HPSII Phosphate Mine

Alachua County Concerns

Anthony Janicki
Thomas Crisman
Patrick Tara
Sam Upchurch

HPS MINING
HPS II, LLC, BROOKER, FL.
NEW RIVER CROSSING
PLAN

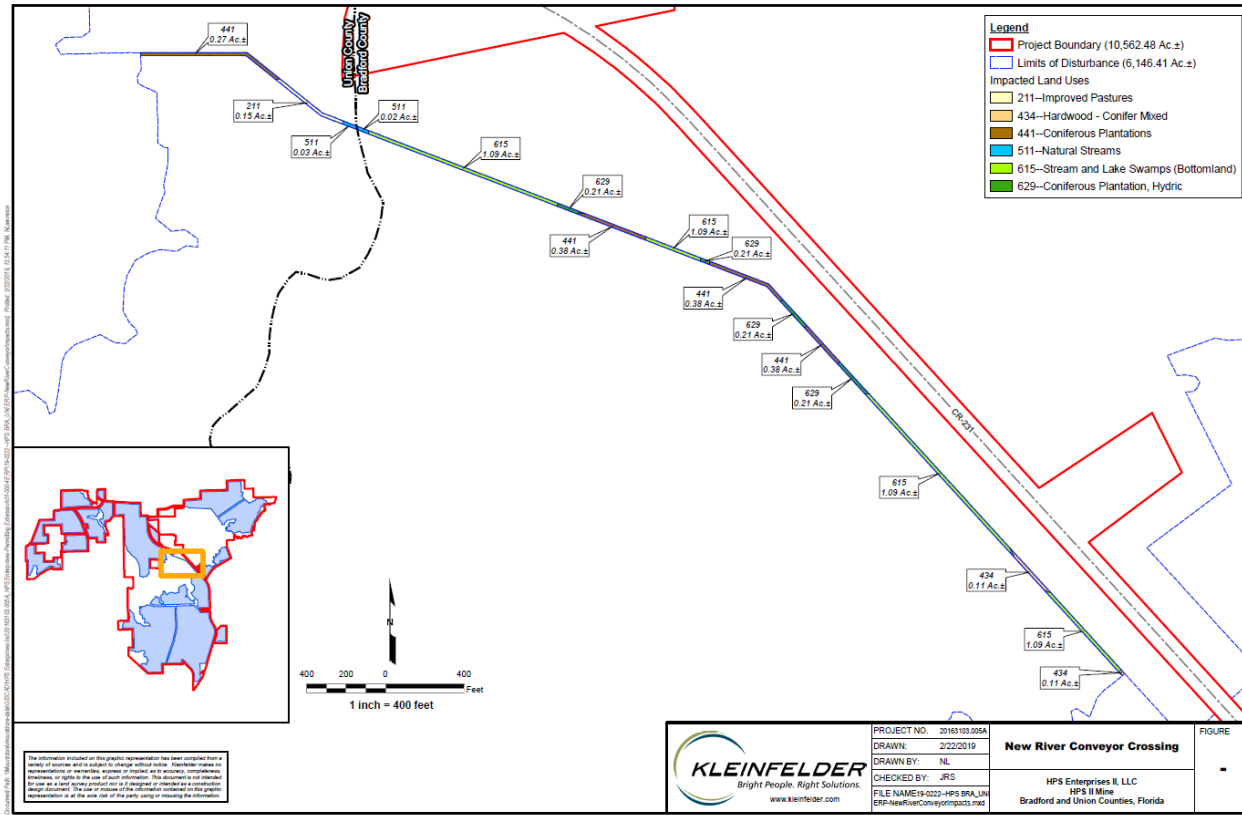
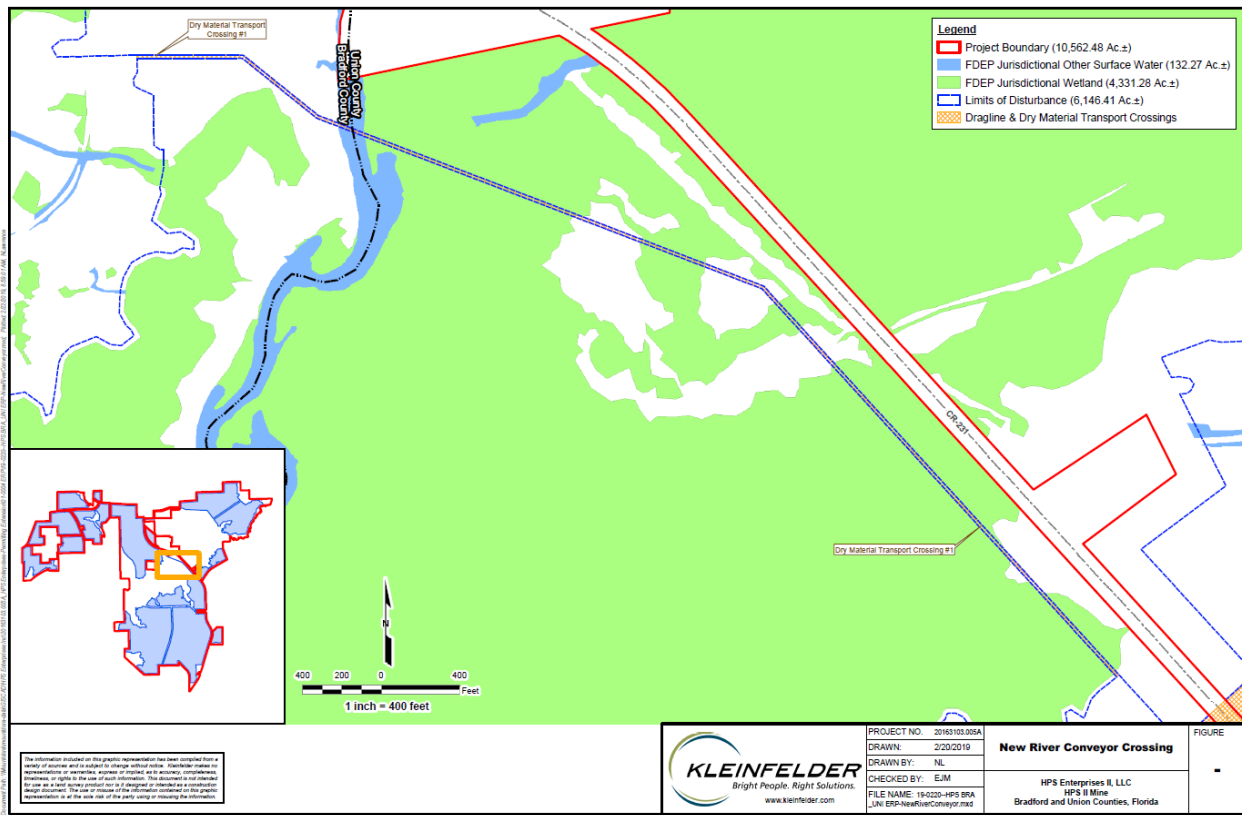
- Hydraulic impacts at river crossing
- The many piers in the channel will cause additional erosion
- The conveyor crossing is extended towards an area where the principle axis of the river more north-south
- Additional debris accumulation possible

Springs

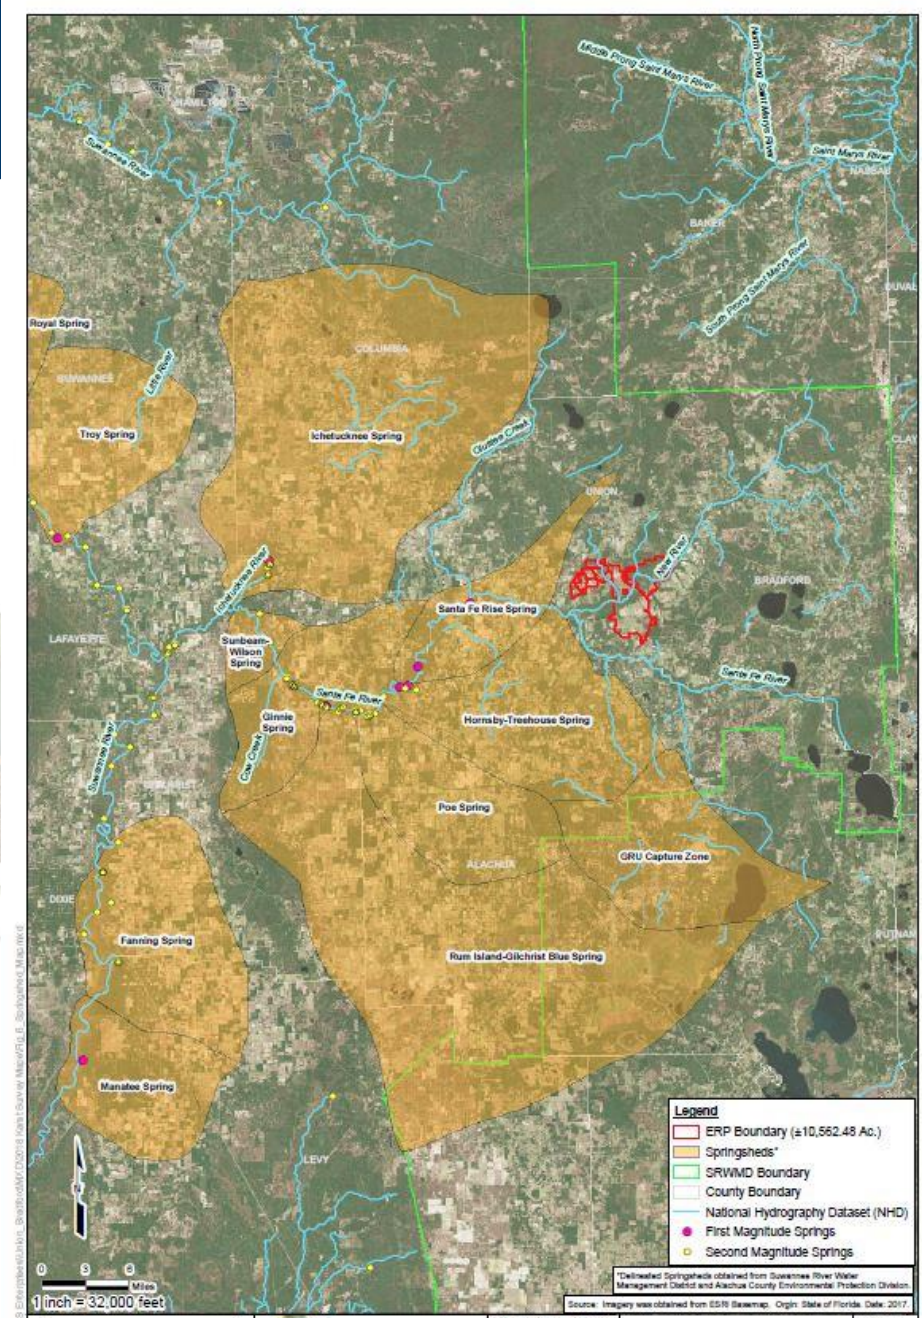
- Upchurch created most of the springshed delineations
- Floridan aquifer potentiometric data in Upper Santa Fe Basin was inadequate
- Unclear who drew springsheds near HPSII mine area

Mining Plan Floodplain Connection ERP 2/19

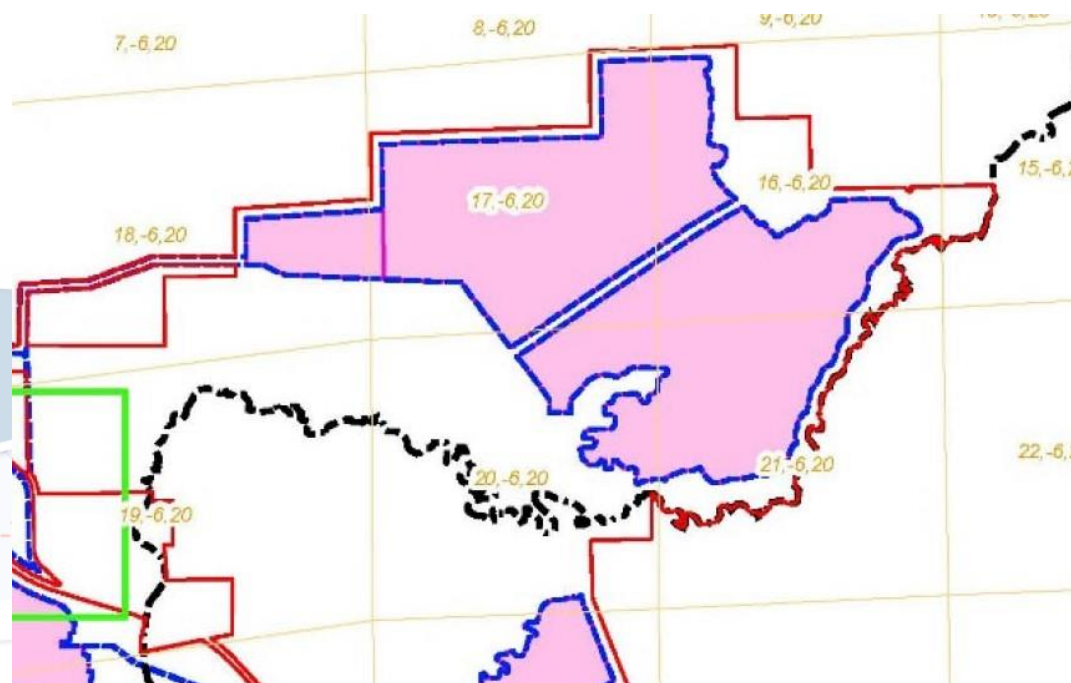
Note the diked channel to ensure stream connection

Upper Floodplain Connection ERP 3/19

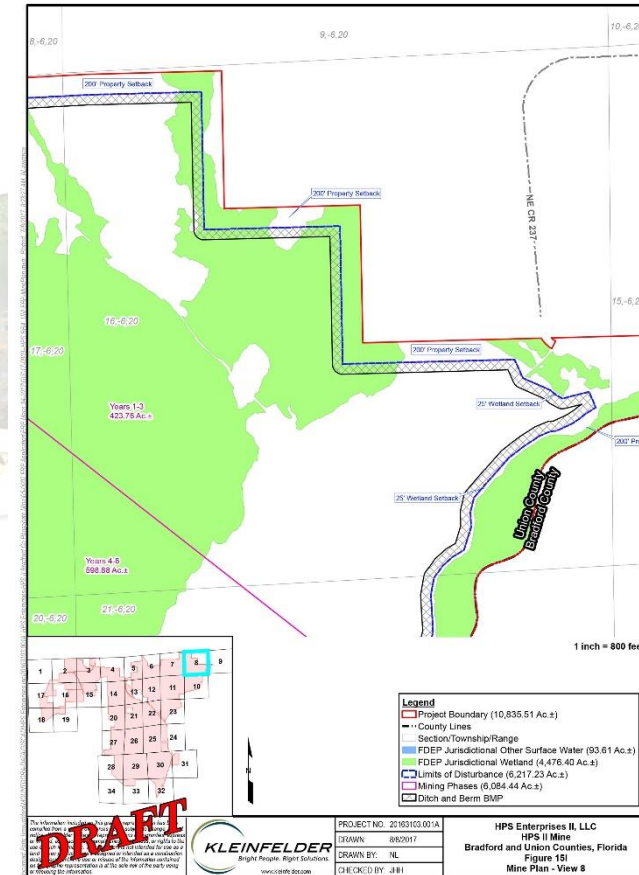
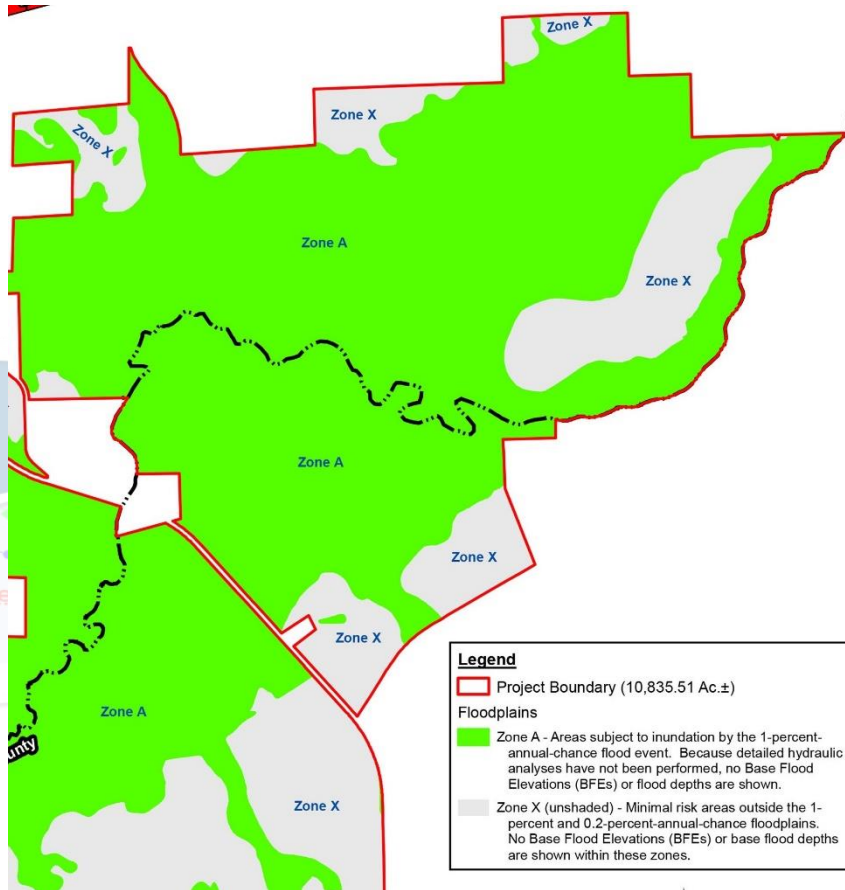
Note blockage of river entry and lack of connection to lower floodplain

Mined Area ERP 3/25

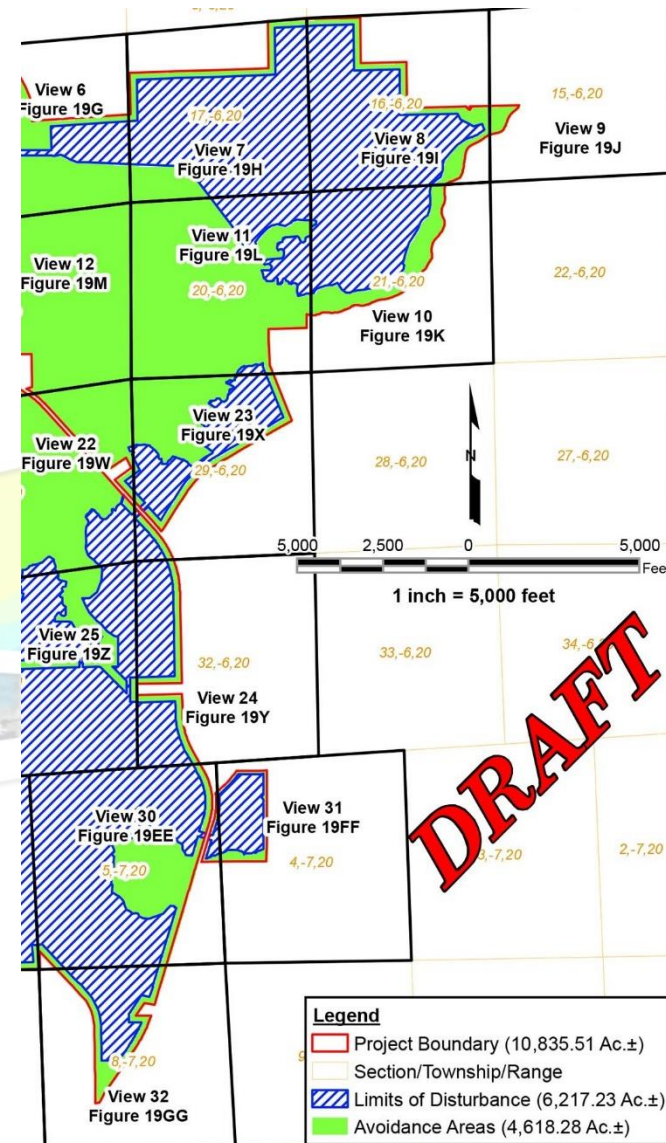
- Disconnect of river from floodplain
- No hydrologic connection through mined area

New River Corridor

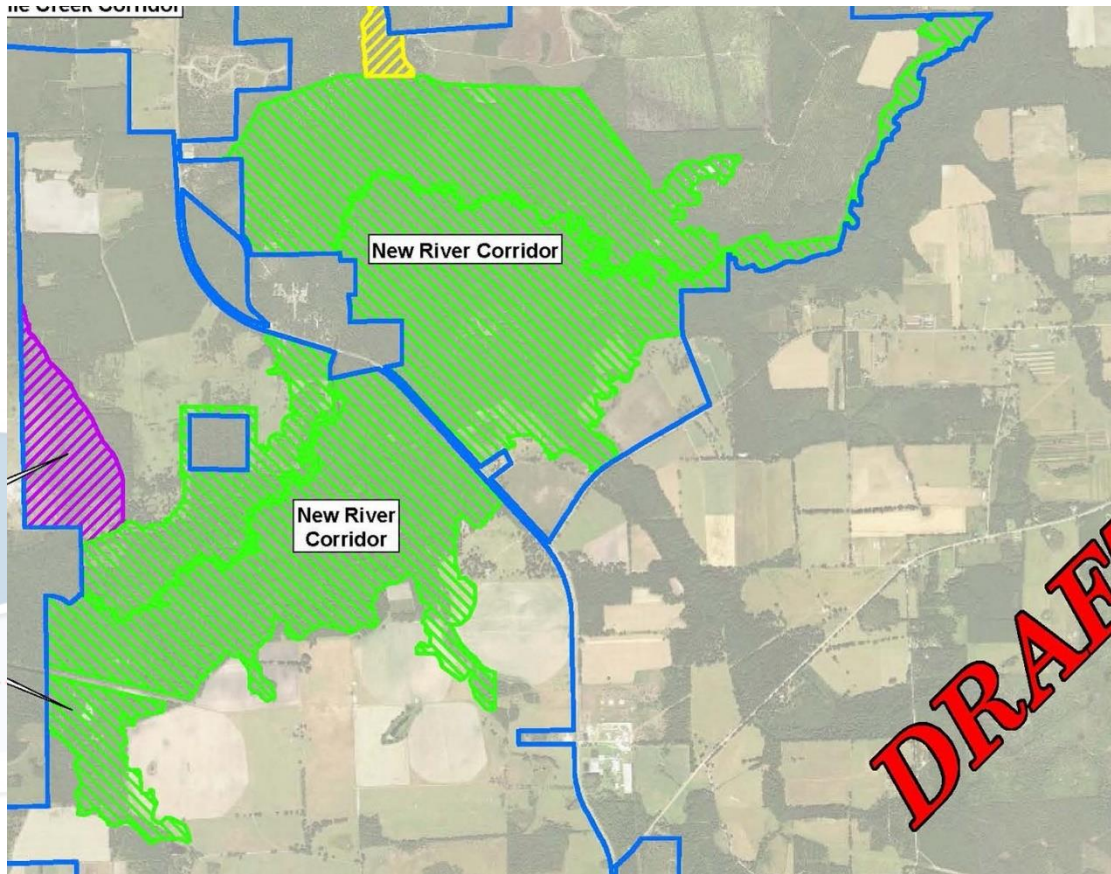
- Monitoring planned for 5 miles of New River within project area only
- NRC limited to river channel in places, especially to northeast
- Fill .38 acre cattle pond on floodplain without cause
- Berm removal at Five Mile Creek entry and another stream to encourage sheet flow

Richard Creek Corridor

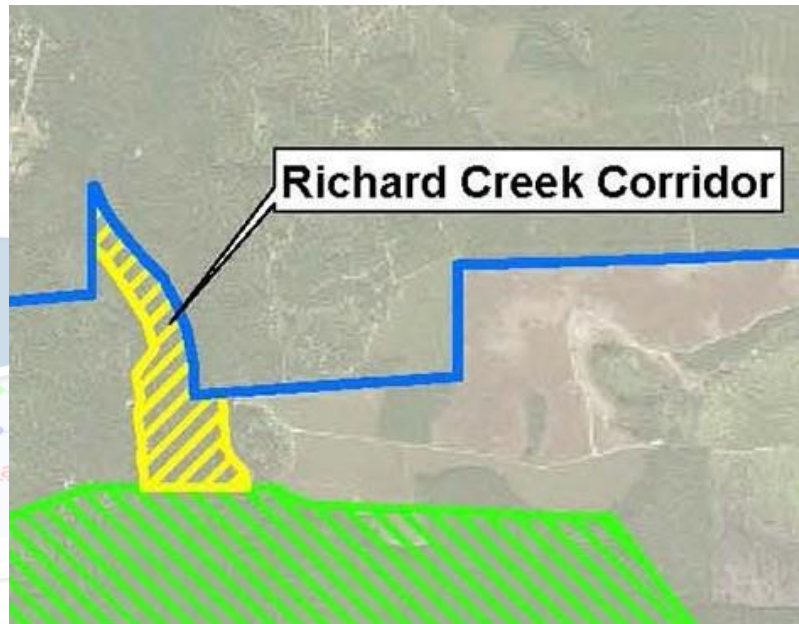
- Northern portion perennial flow
- Southern portion loss of defined channel: a slough to New River
- No upland buffer along eastern stream bank

Five Mile Creek Corridor

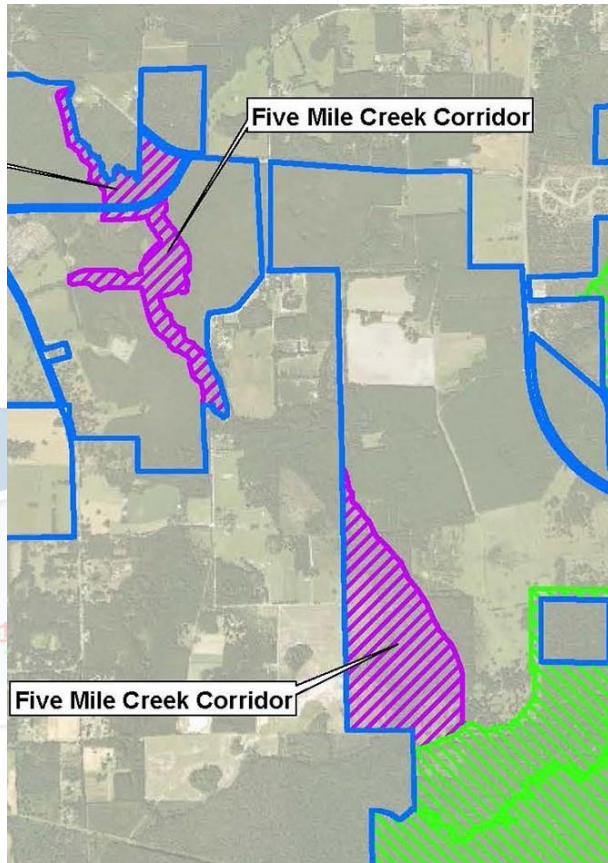
- North and South stream sections not connected with mitigation
- Little upland buffer zone
- Berm removal at boundary with New River Corridor
